REVISED RESPONSE TO REQUEST FOR ADDITIONAL INFORMATION

APR1400 Design Certification

Docket No. 52-046

RAI No.: 129-8085
SRP Section: 03.08.01 – Concrete Containmentment
Application Section: 3.8.1
Date of RAI Issue: 08/05/2015

Figure 1 Section of Containment around IRWST

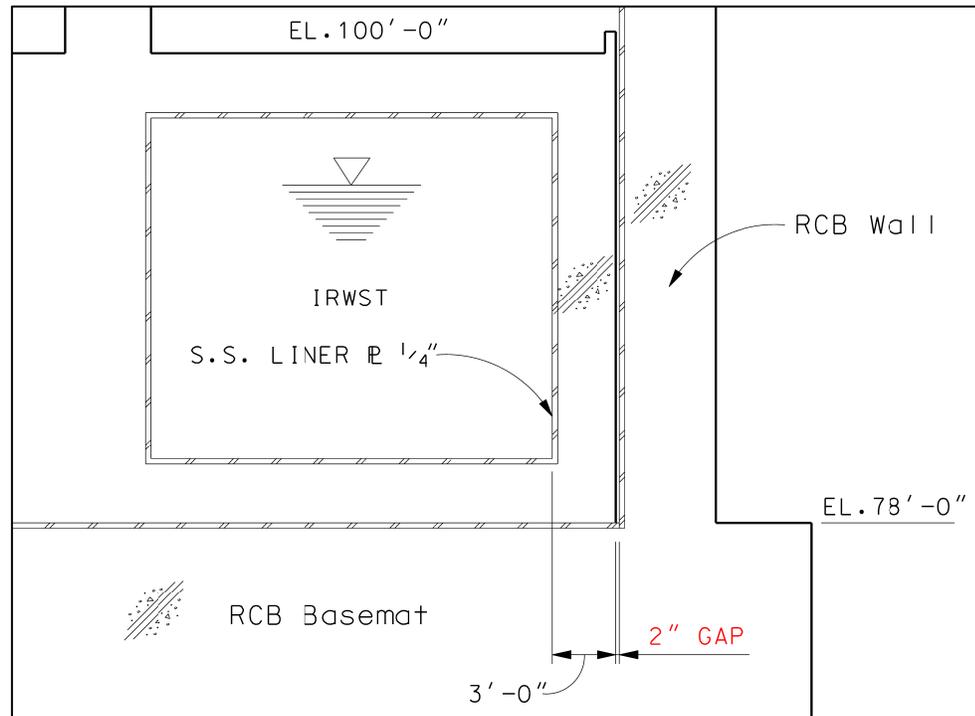
- e. Explain where in DCD Sections 3.8.1.3 and 3.8.3.3 the load descriptions and load combinations for consideration of safety/relief valve actuation loads on the containment and containment internal structures are described and whether or not the safety/relief valve actuation loads include potential direct loads on the structures and potential building dynamic response loads.

- f. DCD Section 3.8.1.3 does not describe the safety/relief valve actuation load, if applicable, and the method used for combining dynamic loads that include SSE, LOCA and safety/relief valve actuation. Provide this information and indicate if it is in accordance with SRP 3.8.1 (including Appendix A) and Regulatory Guide (RG) 1.136, "Materials, Construction, and Testing of Concrete Containments," Revision 3.

- e. DCD Tier 2, Subsection 3.8.1.3 does not describe pilot-operated safety relief valve (POSRV) actuation load since POSRV actuation loads are not applied on the containment wall. The IRWST is separated from the containment wall by a gap of 2 inches, as shown in Figure 1 below. Thus, there is no connection to transfer POSRV actuation loads to the containment wall. Therefore, POSRV actuation loads are not applied to the containment basemat through the containment wall. DCD Tier 2, Subsection 3.8.3.1.8 will be revised, indicated in the attachment associated with this response.
